**Rancho Las Virgenes
Regional Facilities Expansion IV**

Solids Handling and Composting Facilities

LAS VIRGENES MWD / TRIUNFO CSD
RANCHO LAS VIRGENES - REGIONAL FACILITIES EXPANSION IV
SOLIDS HANDLING AND COMPOSTING FACILITIES

ANAEROBIC DIGESTERS AND
 DIGESTER PUMP STATION

06554
 SHEET
 6M-4
 OF 508 SHEETS

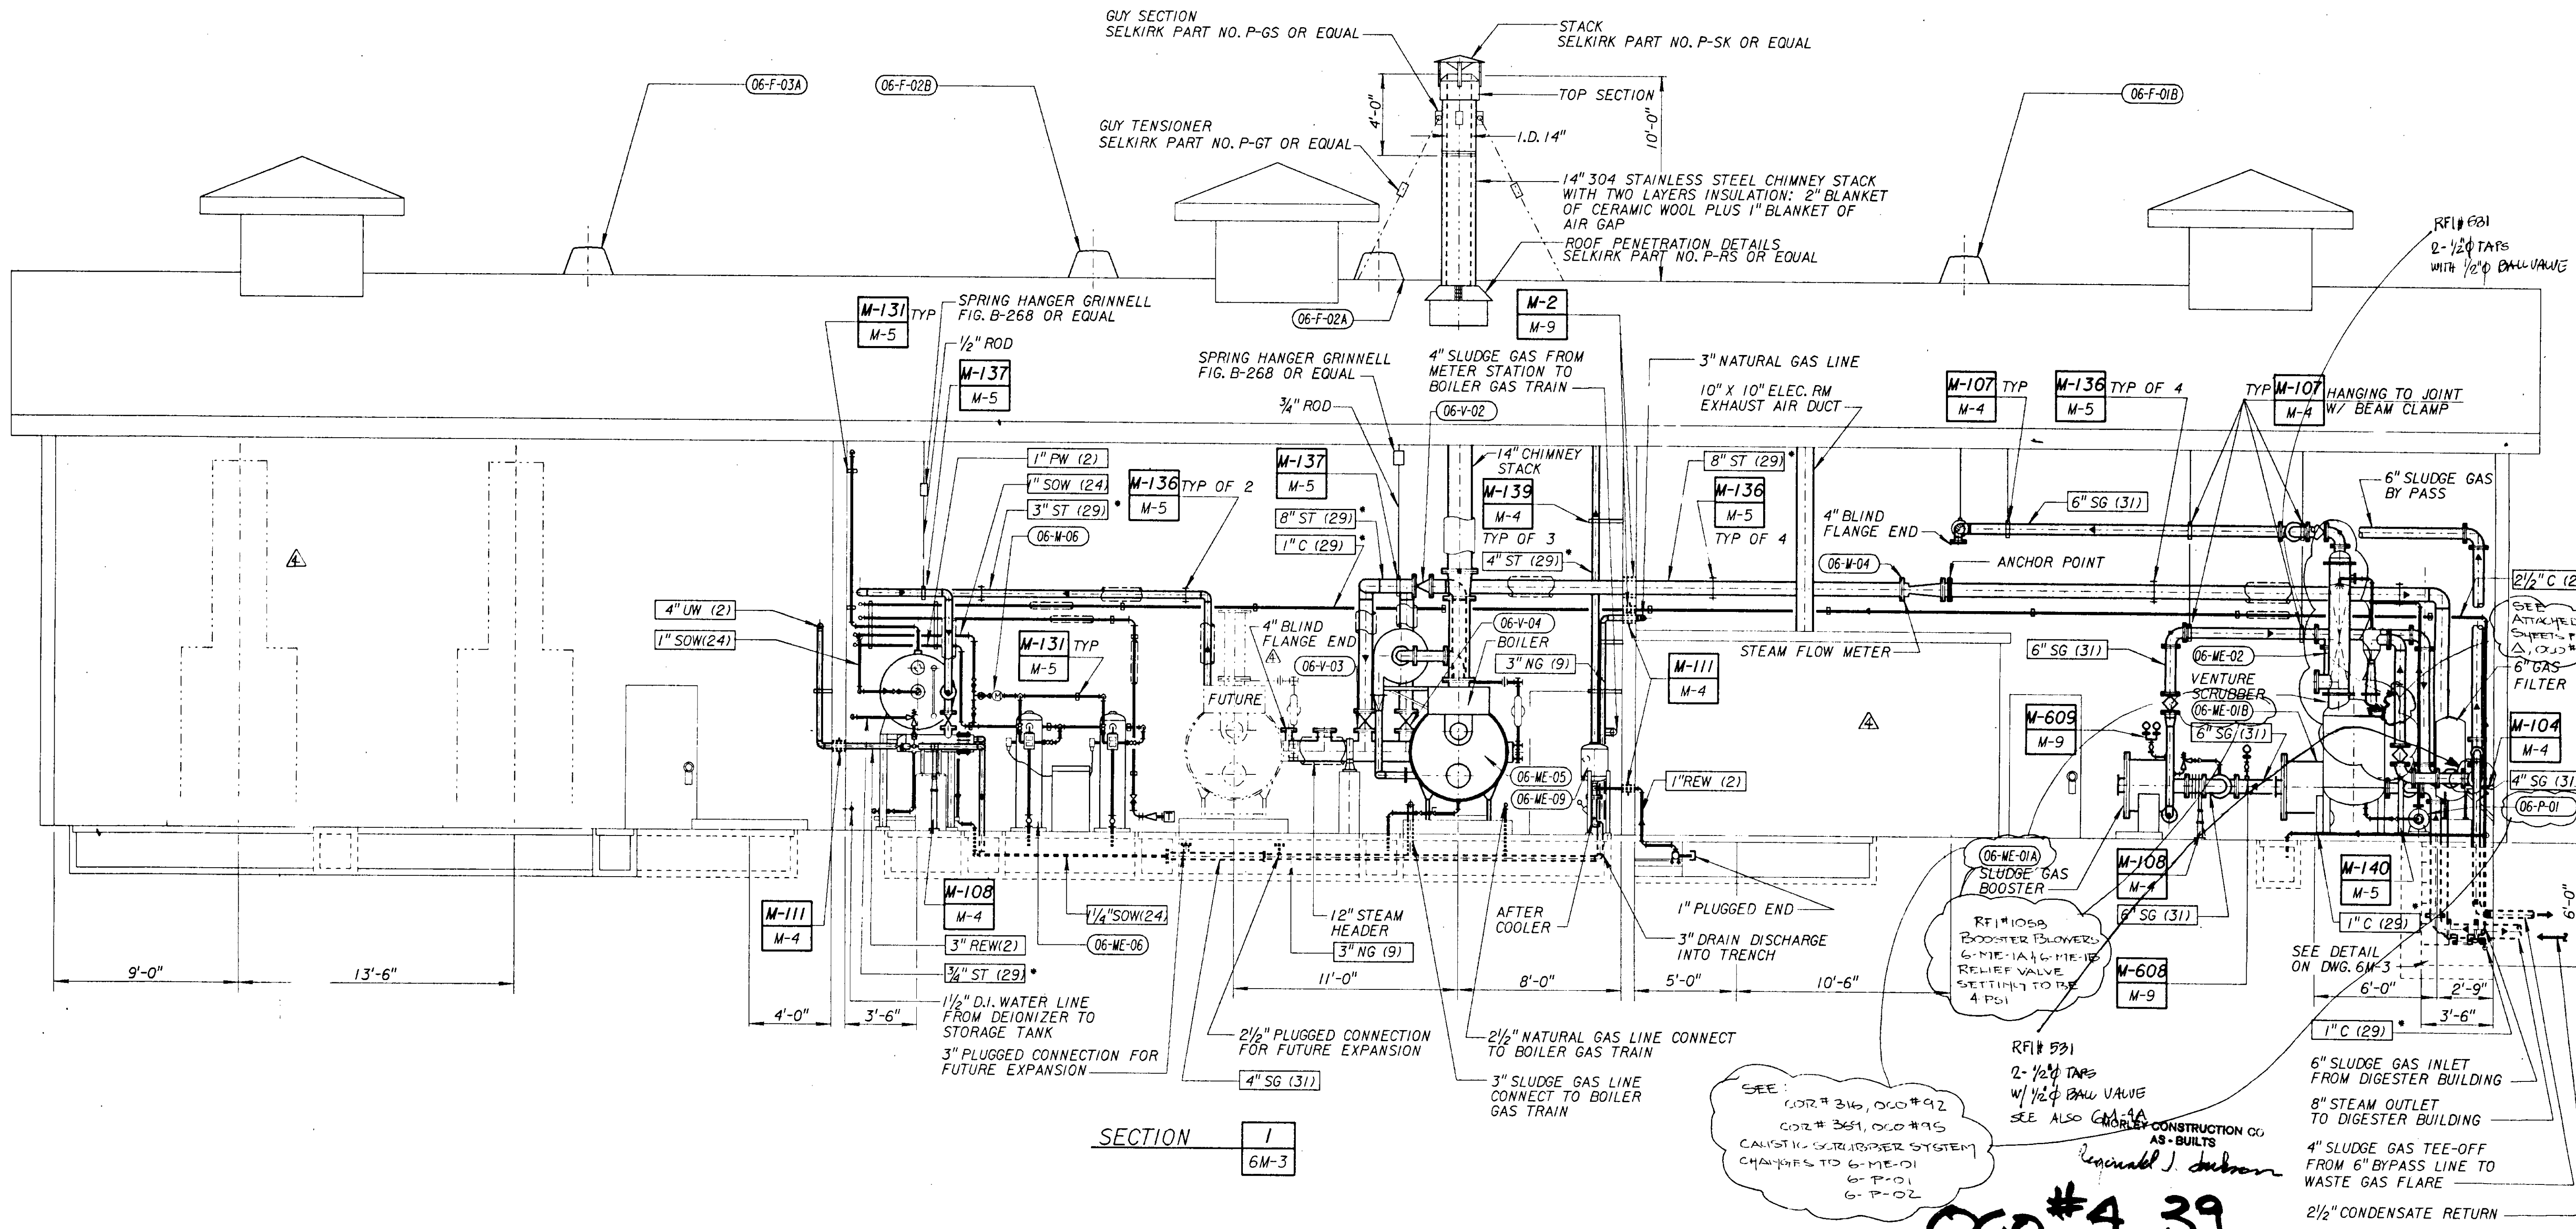
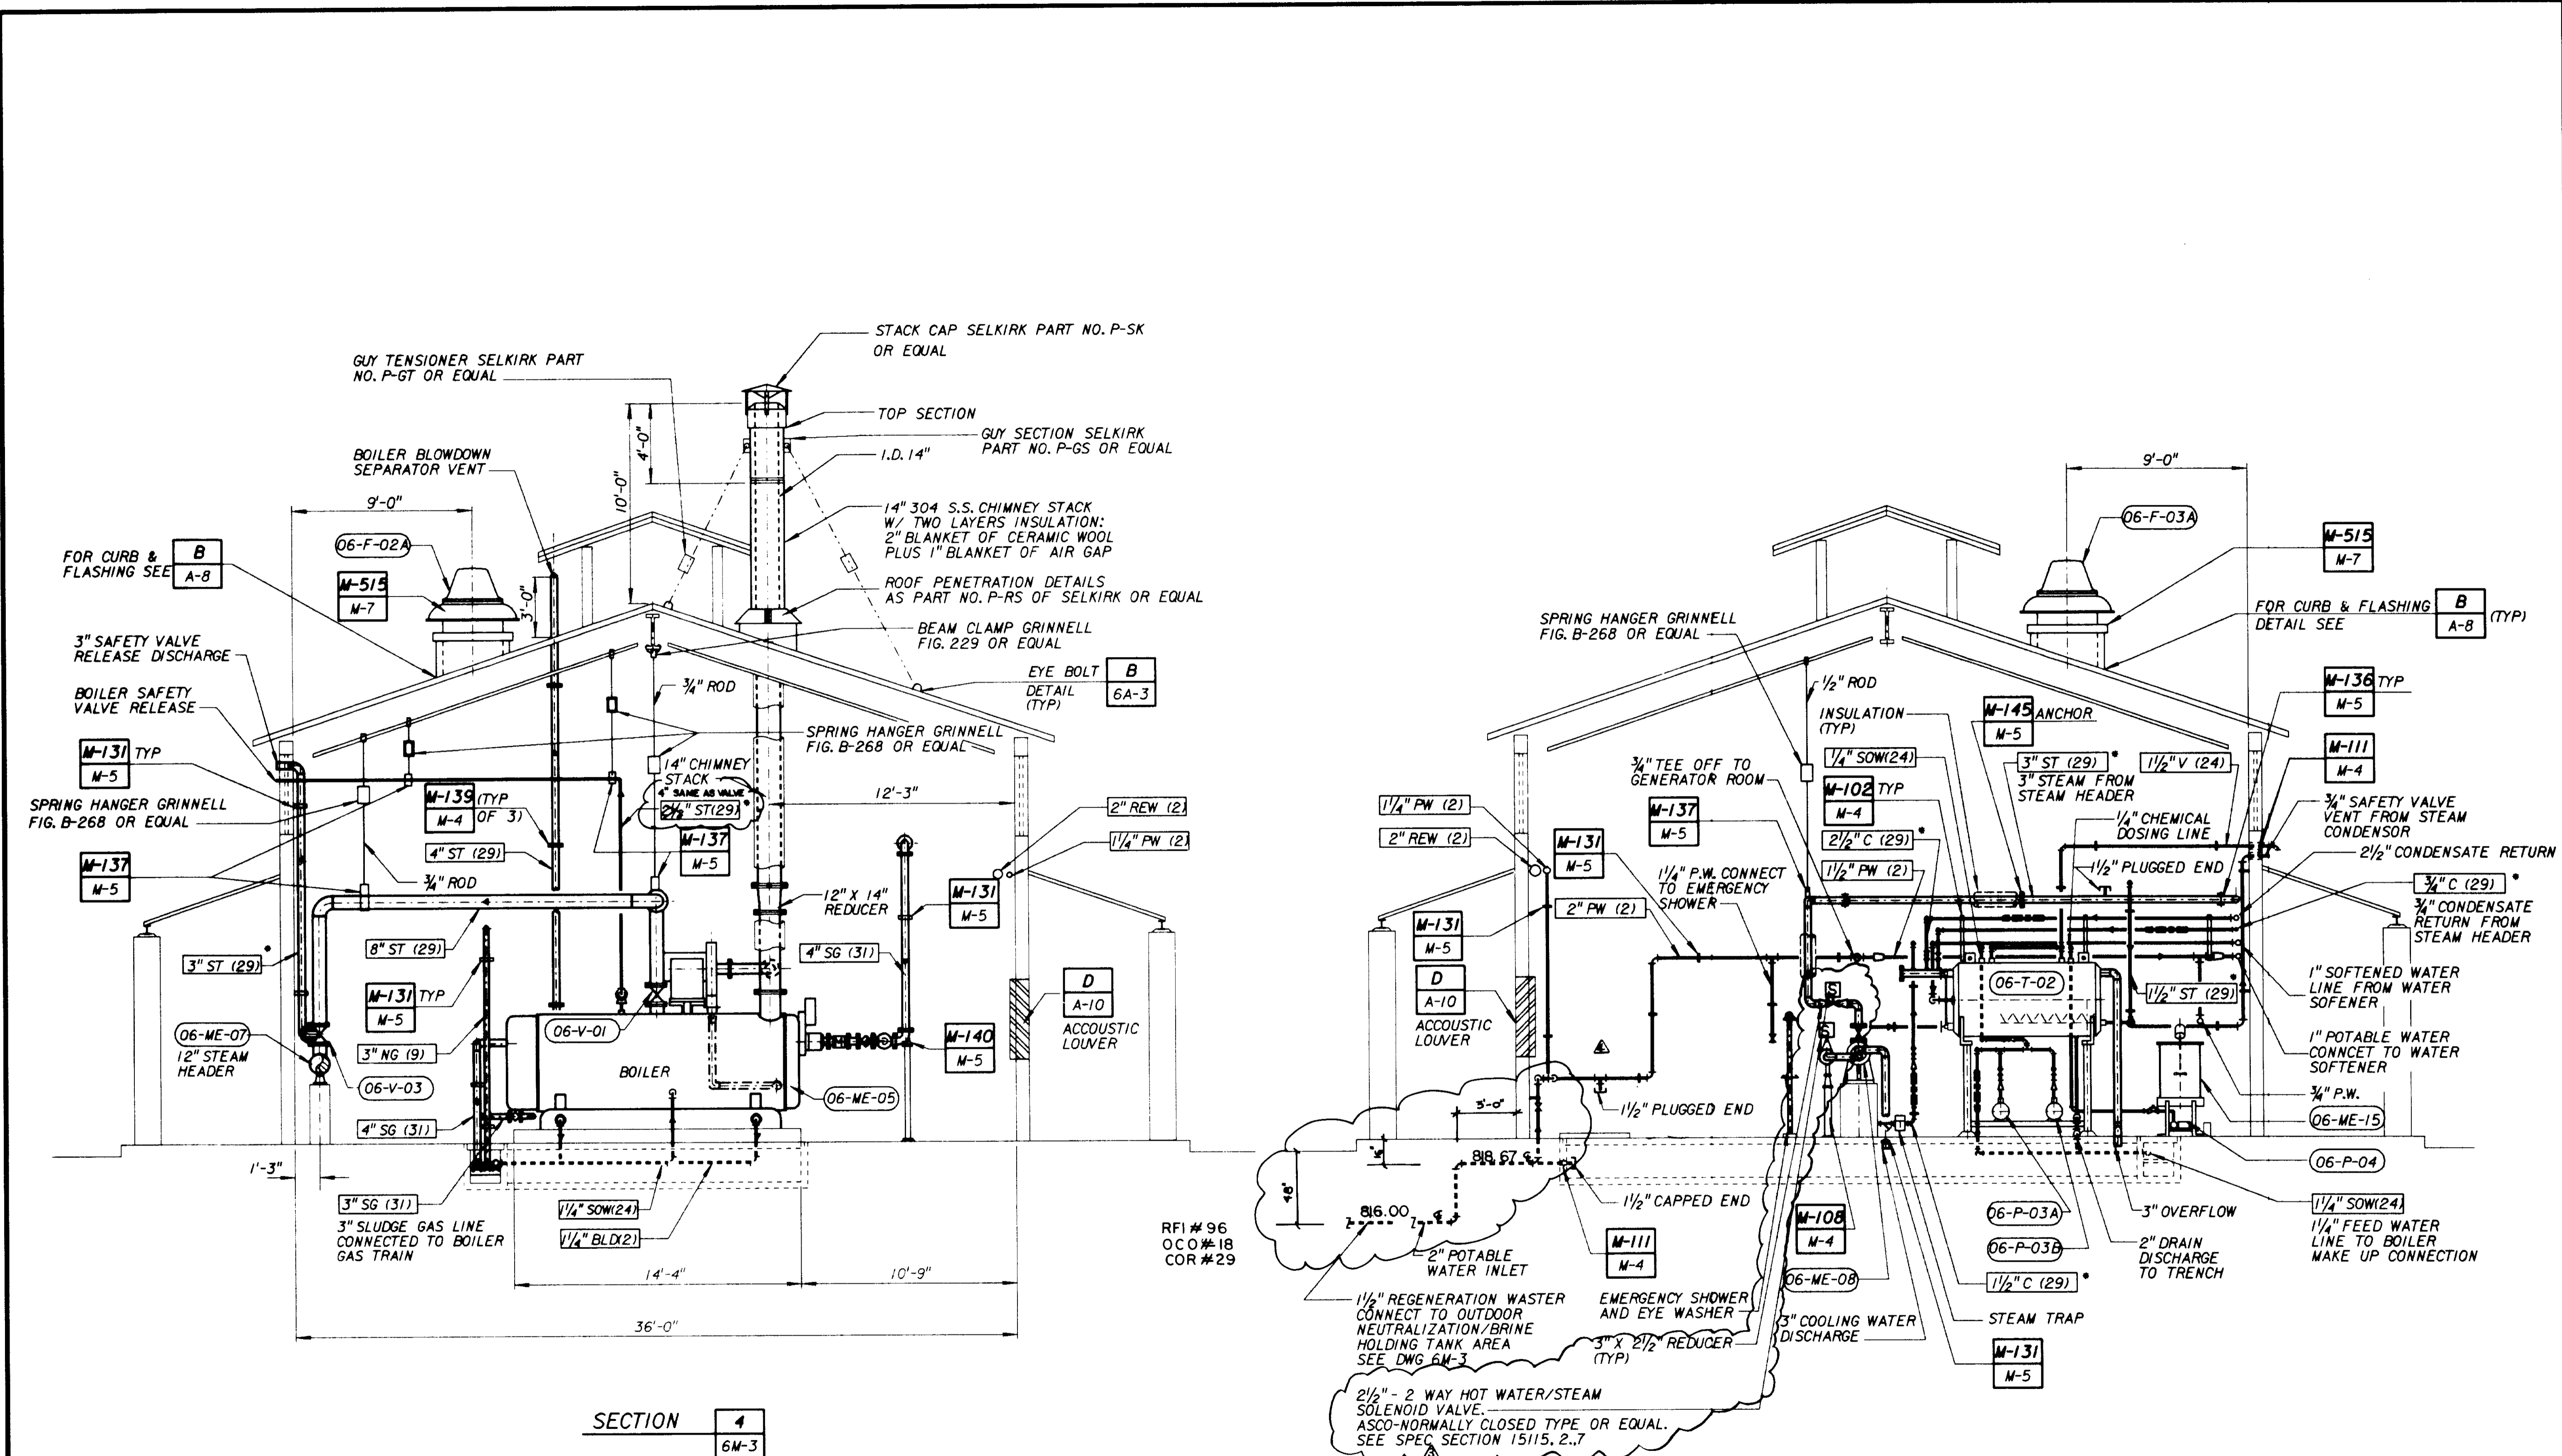
NOTE #1
CAUSTIC CHANGED PER OKA LETTER AUG. 26 '93; RFI # 898
PHILIPS
PRT 343

SEE RFI 891 FOR REVISED PIPING
1" CONDENSATE DISCHARGE INTO TRENCH

SHEET
6M-8
OF 508 SHEETS

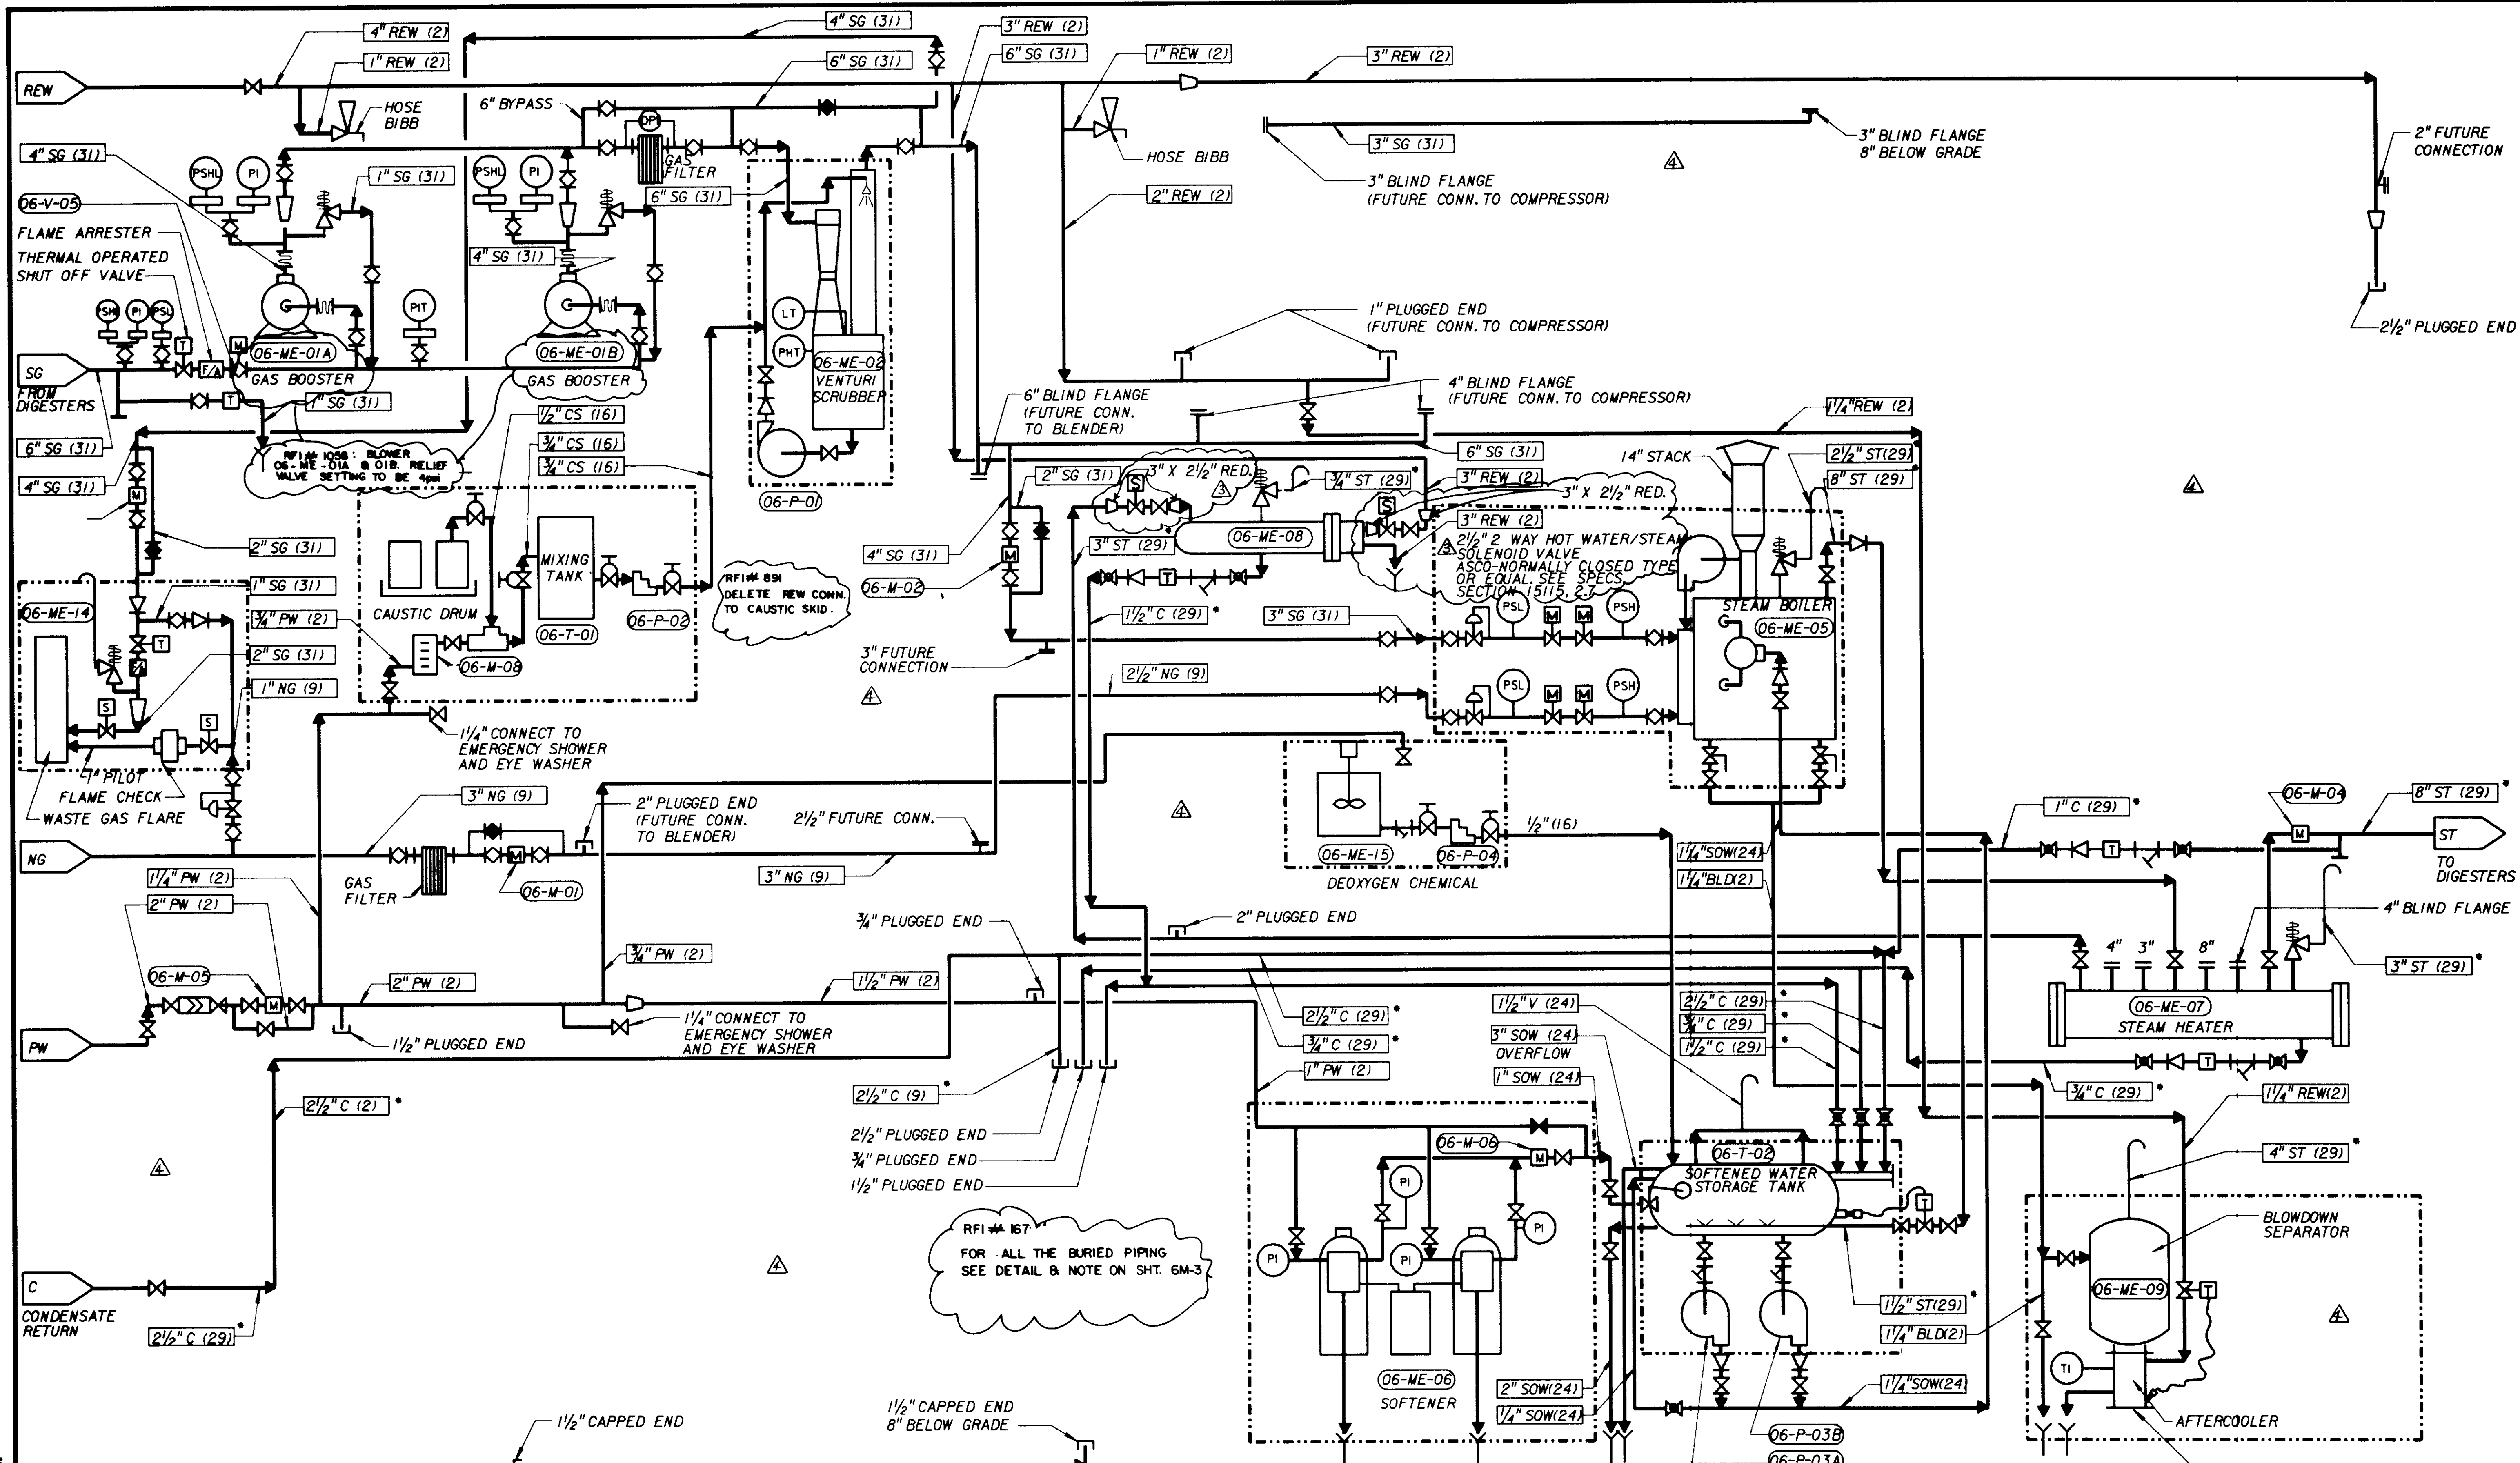
RFI # 167
FOR ALL THE BURIED PIPING
SEE DETAIL & NOTE ON SHT. 6M-3
